PCI-SIG ENGINEERING CHANGE NOTICE

TITLE:	Process Address Space ID (PASID)
DATE:	March 31, 2011
AFFECTED DOCUMENT:	PCI Express Base Specification, Version 3.0
SPONSOR:	AMD, HP

Figure 6-20: PASID TLP Prefix

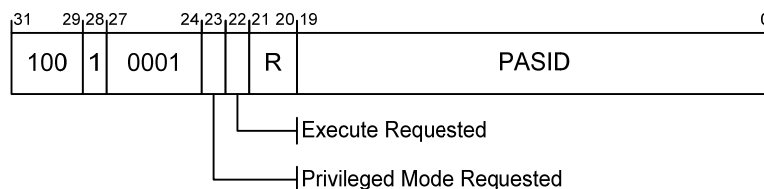
10 Add the following new Section 6.20:

The PASID TLP Prefix is an End-End TLP Prefix as defined in Section 2.2.1. Layout of the PASID TLP Prefix is shown in Figure 6-20 and Table 6-13.

A TLP may contain at most one PASID TLP Prefix.

<u>Bits</u>	<u>Columns</u>
<u>31:29</u>	<u>100b – indicating TLP Prefix</u>
<u>28</u>	<u>1b – indicating End-End TLP Prefix</u>
<u>27:24</u>	<u>0001b – indicating PASID TLP Prefix</u>

<u>Bits</u>	<u>Columns</u>
<u>23</u>	<u>Privileged Mode Requested – If Set indicates a Privileged Mode entity in the Endpoint is issuing the Request, If Clear, indicates a Non-Privileged Mode entity in the Endpoint is issuing the Request.</u> <u>Usage of this bit is specified in Section 6.20.2.3.</u>
<u>22</u>	<u>Execute Requested – If Set indicates the Endpoint is requesting Execute Permission. If Clear, indicates the Endpoint is not requesting Execute Permission.</u> <u>Usage of this bit is specified in Section 6.20.2.2.</u>
<u>21:20</u>	<u>Reserved</u>
<u>19:0</u>	<u>Process Address Space ID (PASID) – This field contains the PASID value associated with the TLP.</u> <u>Usage of this field is defined in Section 6.20.2.1.</u>

Figure 7-138: PASID Extended Capability Structure

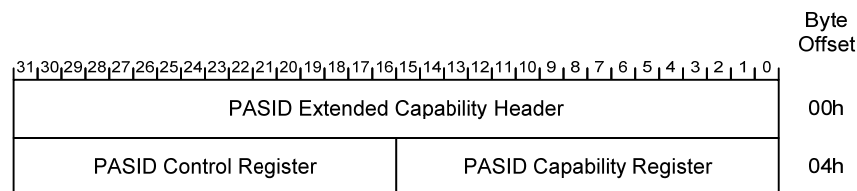
Add the new section 7.28:

Figure 7-138 details allocation of the register bits in the PASID Extended Capability structure.

Figure 7-140: PASID Capability Register

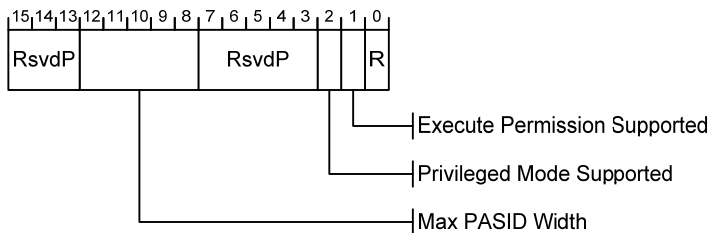
Figure 7-140 details the allocation of register bits of the PASID Capability register; Table 7-118 provides the respective bit definitions.

<u>Bit Location</u>	<u>Register Description</u>	<u>Attributes</u>
<u>0</u>	<u>Reserved</u>	<u>RsvdP</u>
<u>1</u>	<u>Execute Permission Supported</u> – If Set, the Endpoint supports sending TLPs that have the Execute Requested bit Set. If Clear, the Endpoint will never Set the Execute Requested bit.	<u>RO</u>
<u>2</u>	<u>Privileged Mode Supported</u> – If Set, the Endpoint supports operating in Privileged and Non-Privileged modes, and supports sending requests that have the Privileged Mode Requested bit Set. If Clear, the Endpoint will never Set the Privileged Mode Requested bit.	<u>RO</u>
<u>7:3</u>	<u>Reserved</u>	<u>RsvdP</u>
<u>12:8</u>	<u>Max PASID Width</u> – Indicates the width of the PASID field supported by the Endpoint. The value n indicates support for PASID values 0 through 2^n-1 (inclusive). The value 0 indicates support for a single PASID (0). The value 20 indicates support for all PASID values (20 bits). This field must be between 0 and 20 (inclusive).	<u>RO</u>

Figure 7-141: PASID Control Register

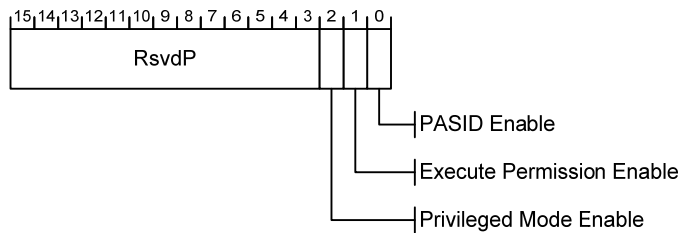
Figure 7-141 details the allocation of register bits of the PASID Control register; Table 7-119 provides the respective bit definitions.

<u>Bit Location</u>	<u>Register Description</u>	<u>Attributes</u>
<u>0</u>	<p>PASID Enable – If Set, the Endpoint is permitted to send and receive TLPs that contain a PASID TLP Prefix. If Clear, the Endpoint is not permitted to do so.</p> <p>Behavior is undefined if the Endpoint supports ATS and this bit changes value when ATS Enable (E) is Set (see the <i>Address Translation Specification</i>).</p> <p>Default is 0b.</p>	RW
<u>1</u>	<p>Execute Permission Enable – If Set, the Endpoint is permitted to send Requests that have Execute Requested Set. If Clear, the Endpoint is not permitted to do so.</p> <p>Behavior is undefined if the Endpoint supports ATS and this bit changes value when ATS Enable is Set (see the <i>Address Translation Specification</i>).</p> <p>If Execute Permission Supported is Clear, this bit is RsvdP.</p> <p>Default is 0b.</p>	RW / RsvdP (see description)
<u>2</u>	<p>Privileged Mode Enable – If Set, the Endpoint is permitted to send Requests that have the Privileged Mode Requested Set. If Clear, the Endpoint is not permitted to do so.</p> <p>Behavior is undefined if the Endpoint supports ATS and this bit changes value when ATS Enable is Set (see the <i>Address Translation Specification</i>).</p> <p>If Privileged Mode Supported is Clear, this bit is RsvdP.</p> <p>Default is 0b.</p>	RW / RsvdP (see description)
